ADDENDUM No. 1

REQUEST FOR QUOTATIONS (RFQ) No.: 1220-040-2022-036

TITLE: Bear Creek Park Lights Event

ADDENDUM ISSUE DATE: April 26th, 2022

SCHEDULE A-1 – SITE MAP & LEGEND

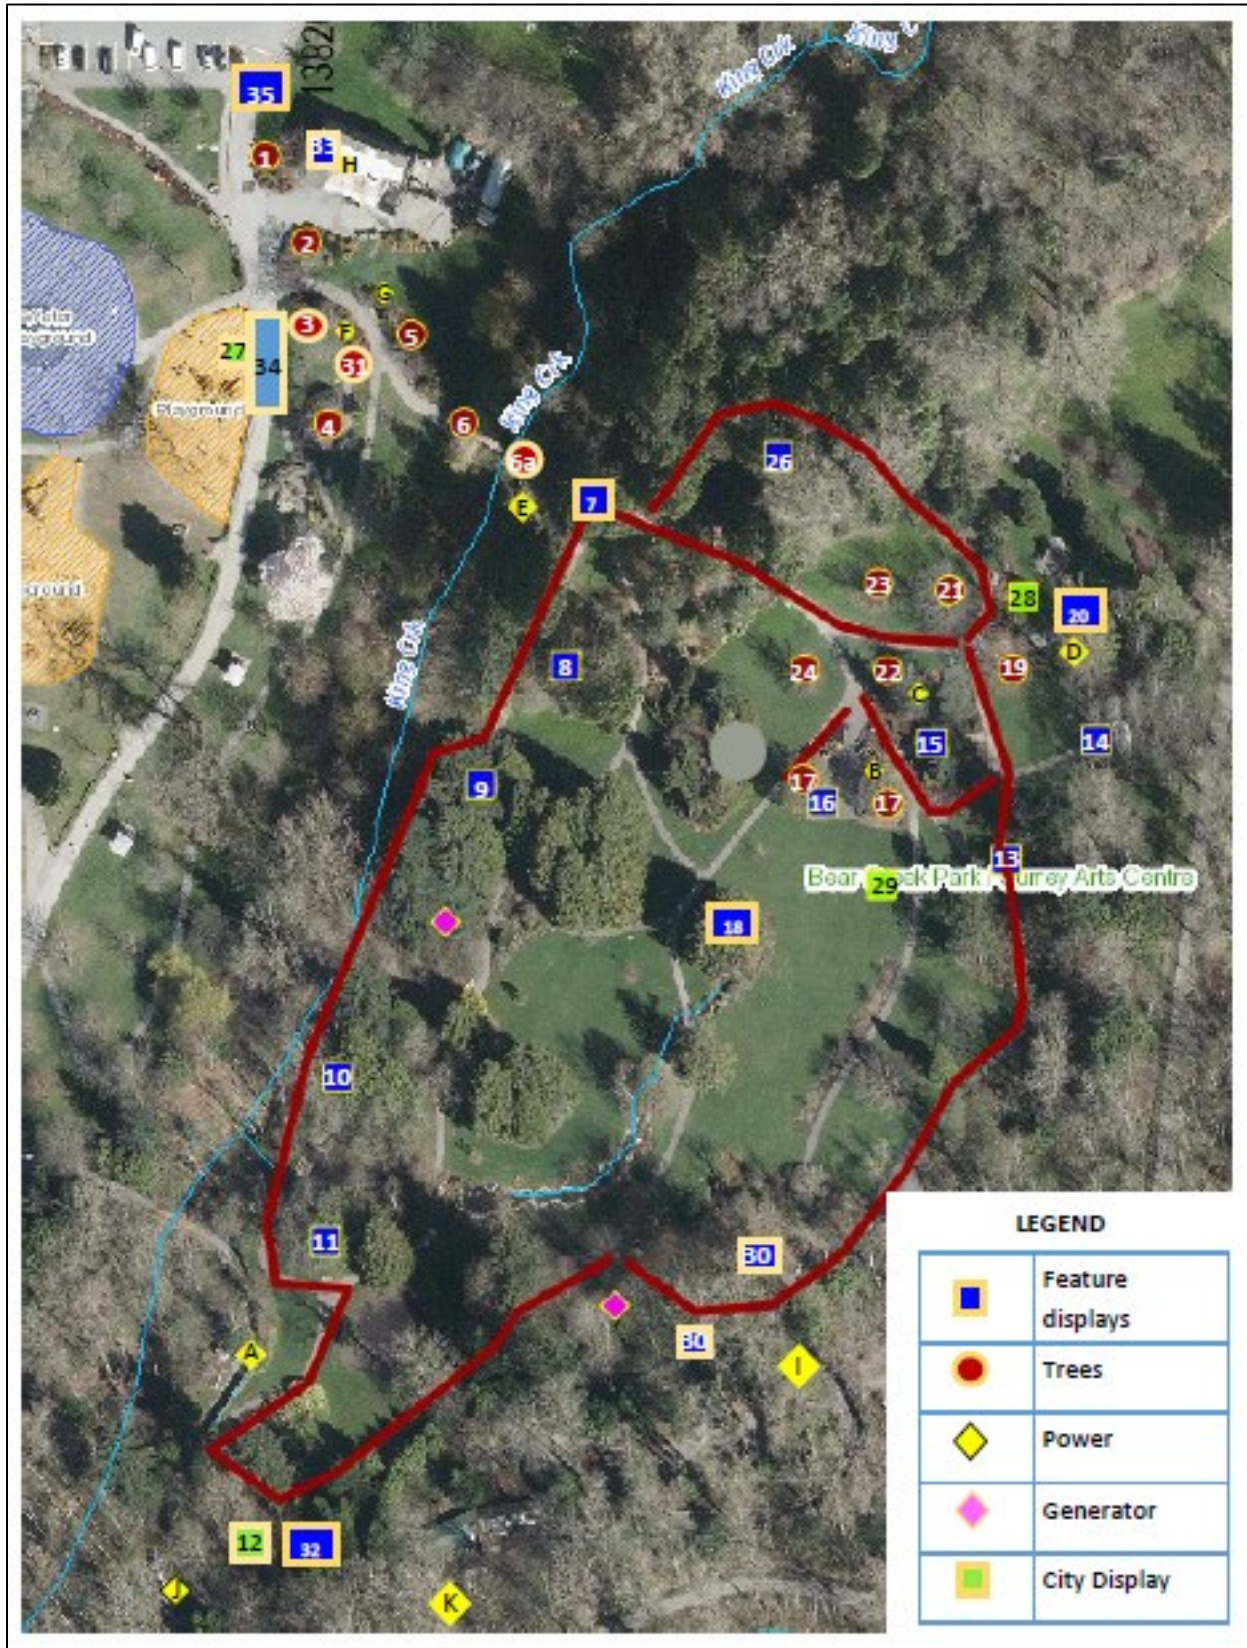
SCHEDULE A-1 – SITE MAP & LEGEND is to be deleted in its entirety and substituted with SCHEDULE A-1 – SITE MAP & LEGEND as attached to this Addendum No. 1. Please note that Feature #25 has been removed from the map and #35 has been added for an entry archway.
